Project	IEEE 802.16 Broadband Wireless Access Working Group < http://ieee802.org/16 >	
Title	Clarification on transmitter structure for MIMO precoding	
Date Submitted	2005-01-21	
Source(s)	Qinghua Li, Xintian Eddie Lin, Alexei Davydov, Nageen Himayat, Minnie Ho, Sumeet Sandhu, Uri Perlmutter, Yuval Lomnitz, Randall Schwartz, Jose Puthenkulam Intel Corporation	qinghua.li@intel.com Voice: +1-408-765-9698
Re:		
Abstract		
Purpose	Adoption of proposed changes into P802.16e Crossed out indicates deleted text, <u>underlined blue indicates new text change to the Standard</u>	
Notice	This document has been prepared to assist IEEE 802.16. It is offered as a basis for discussion and is not binding on the contributing individual(s) or organization(s). The material in this document is subject to change in form and content after further study. The contributor(s) reserve(s) the right to add, amend or withdraw material contained herein.

Clarification on Transmitter Structure for MIMO Precoding

Qinghua Li and Xintian Eddie Lin
Intel Corporation

Figure 251h Illustration of Matrix C with vertically encoding for optional zones in DL.

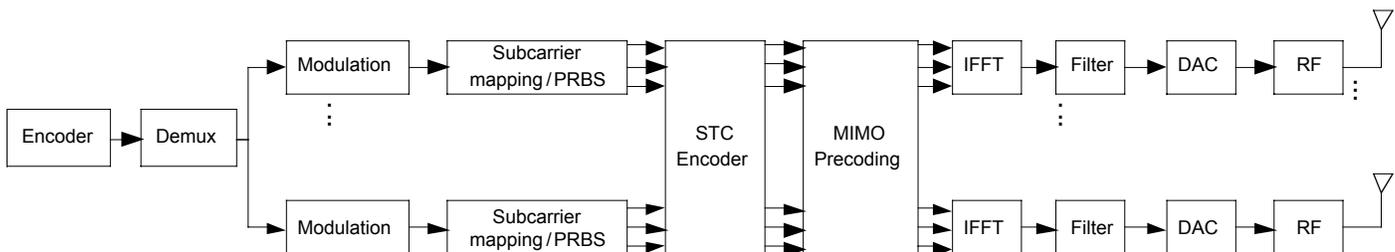
Added at the end (i.e., line 27) in section 8.4.8.3.6 on page 344 of [1] as follows

[In Figure 251h, the STC encoder can employ any matrixes defined in sections 8.4.8.3.3, 8.4.8.3.4, and 8.4.8.3.5 whose number of output \(i.e. rows\) is equal or less than the number of the BS antennas. The Demux assigns bits to multiple data streams according to the modulation employed by the stream.](#)
